Committee of Experts on the Transport of Dangerous Goods and on the Globally Harmonized System of Classification and Labelling of Chemicals

Sixty-fourth session

UN 38.3 Lithium battery testing and amendments to the T.5 external short circuit test

Transmitted by PRBA – The Rechargeable Battery Association*, **

Example of plot illustrating metal case temperature vs. internal cell temperature

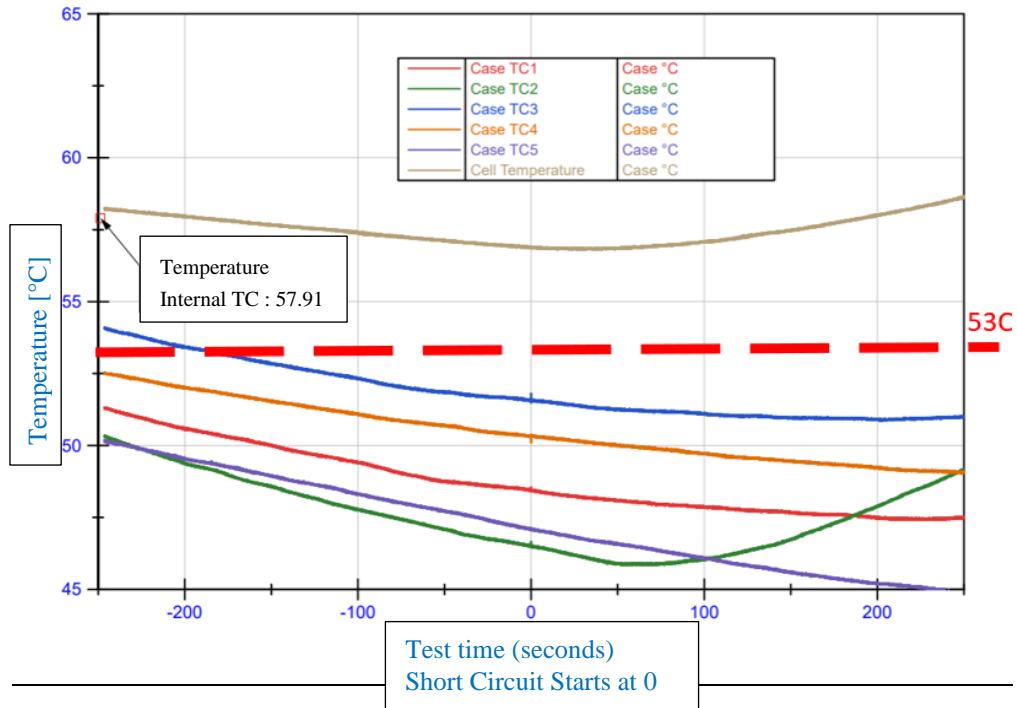
4. Large batteries often need to be removed from a thermal chamber prior to short circuit conditions due to safety concerns with conducting the short circuit test in a chamber. Batteries with a metal case have difficulties maintaining the temperature at 57 ± 4 °C prior to short circuit test start when removed from the thermal chamber. Once a battery is removed from the thermal chamber, it generally takes 5 to 10 minutes to set-up the short circuit equipment and data-logging before the test can begin. The external metal casing temperature drops

rapidly as it equilibrates with ambient lab temperature. However, the internal cell temperature is rather stable during this test setup period (reference Figure).

5. The internal cell temperature is the critical temperature for performing the short circuit test faithfully. It is believed that as long as the cell temperature is 57 ± 4 °C the intent of the test is met.
6. PRBA therefore proposes a change to the text of the T.5 test procedure to clarify the temperature measuring point.

“The cell or battery to be tested shall be heated for a period of time necessary to reach a homogeneous stabilized temperature of 57 ± 4 °C, measured on external case or an internal cell. This period of time depends on the size and design of the cell or battery and should be assessed and documented. If this assessment is not feasible, the exposure time shall be at least 6 hours for small cells and small batteries, and 12 hours for large cells and large batteries. Then the cell or battery at 57 ± 4 °C shall be subjected to one short circuit condition with a total external resistance of less than 0.1 ohm.

This short circuit condition is continued for at least one hour after the cell or battery ~~external case~~ temperature has returned to 57 ± 4 °C, or in the case of the large batteries, has decreased by half of the maximum temperature increase observed during the test and remains below that value.”
